PHASE 2 - WESLEY BRADLEY PARK

Vertical sidebar containing title block information: Title: COVER SHEET FOR CIVIL PLANS PHASE 2 - WESLEY BRADLEY PARK; For: WESLEY HOMES 815 SOUTH 216TH STREET DES MOINES, WA 98190 (206) 870-1209; Scale: Horizontal 1" = 80', Vertical N/A; Job Number: 16718; Sheet: C1 of C21; Date: 5/17/24; Designer: CK; Drawn: BOK; Checked: CMV; Approved: DKB; Date: 5/17/24; Professional Engineer Seal for Dan Balmelli, No. 25672, State of Washington, expires 5/17/24; Property Address: 707 39TH AVE. S.E. PUYALLUP, WA 98374.

Job Number: **16718**
Sheet: **C20** of **C21**

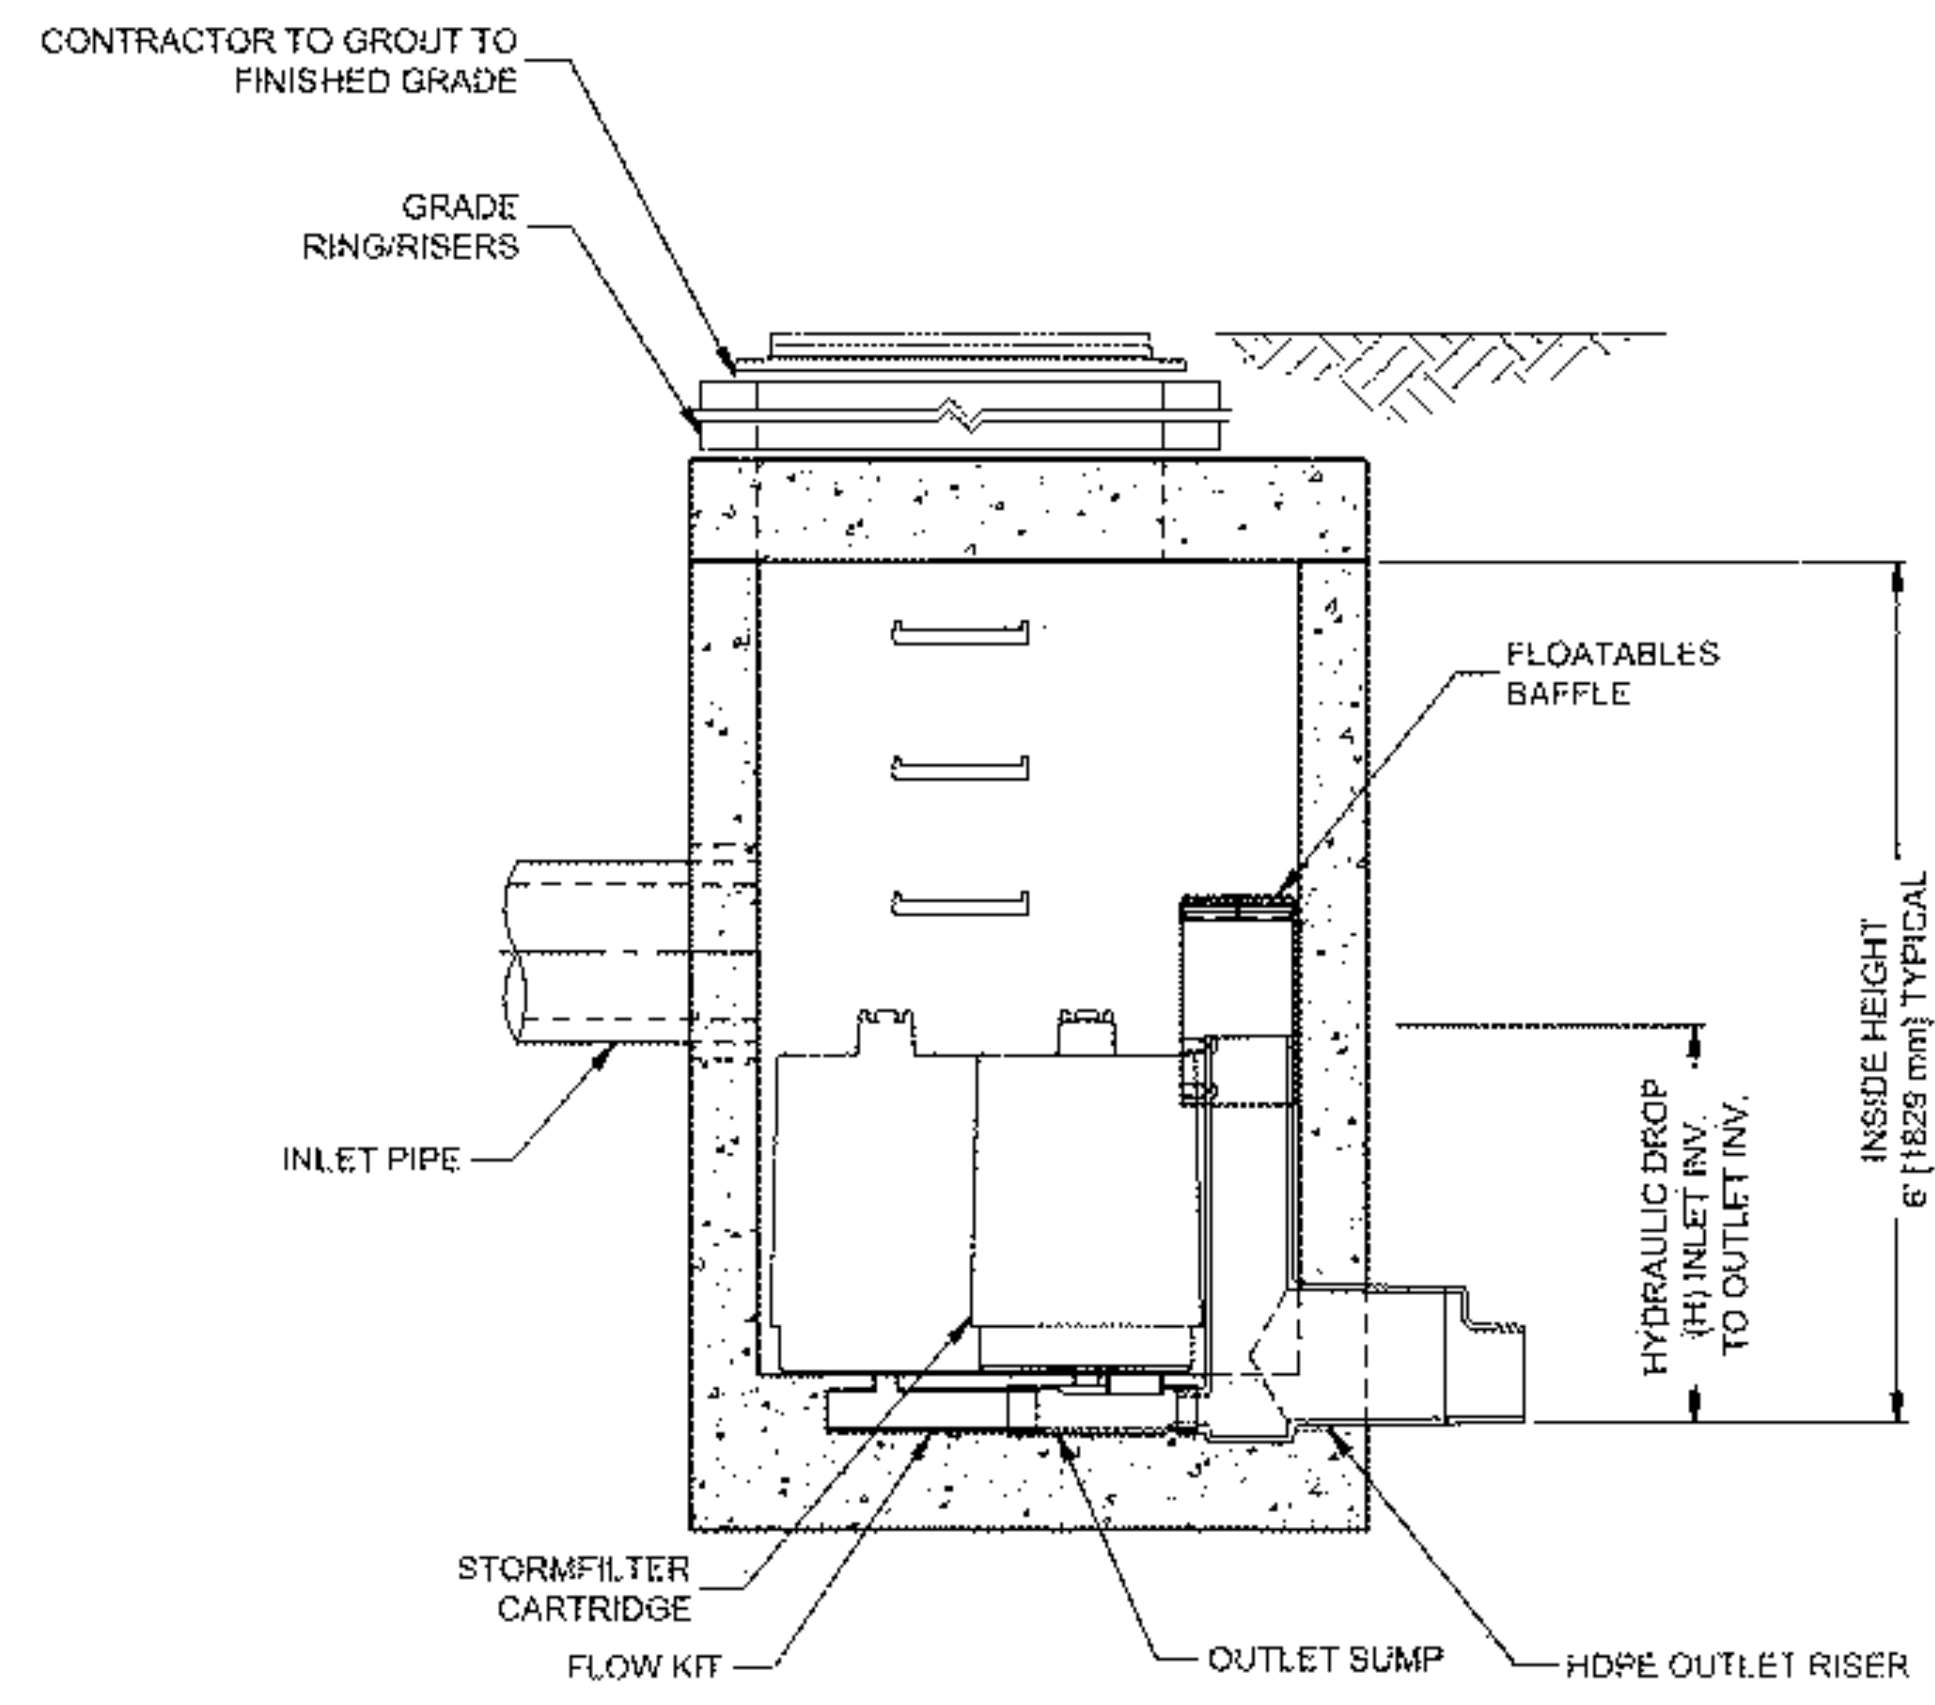
NOTES/SPECIAL REQUIREMENTS:
Use 8in pipe per City Stds. (Plans, Sheet C20 of 21)
* PER ENGINEER OF RECORD PIPE HAS BEEN REVISED.
